CITY OF FORT COLLINS

ADDENDUM No. 2

BID #5681

FOSSIL CREEK COMMUNITY PARK

WOODEN BRIDGE PLAN
FOSSIL CREEK COMM. PARK
JOB NO. 39262.00
3/14/02
1 OF 5

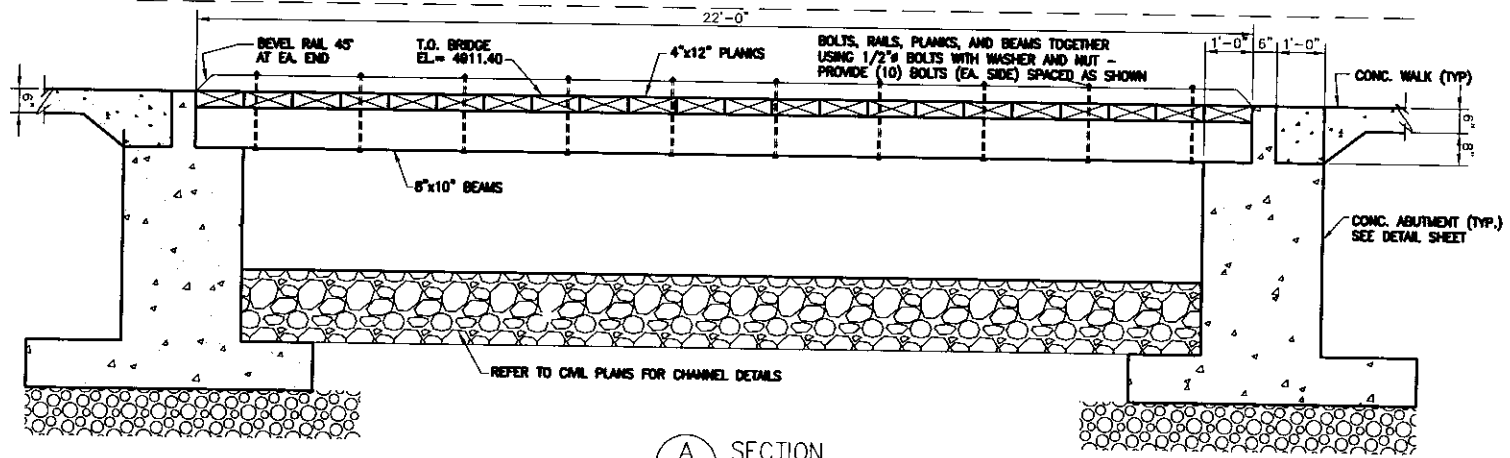
1. Wooden Bridge Plan and Details (sheet after D20.3 and before D21.1), This drawing sheet shall be replaced by the five attached 8.5 x 11 sheets
2. Sheets D21.1 and D21.2, The General Notes on these sheets apply to the concrete bridge abutments only. Refer to specification section 02890 for information regarding the bridges.
3. Sheet D4.5, Detail 1, The top rail of the chainlink fence shall be 1.625" outside diameter (not 1.875").
4. Sheets P4, P6 and P14, Unless otherwise noted, the edger around the planting beds on these sheets shall be 6" Concrete Edger.
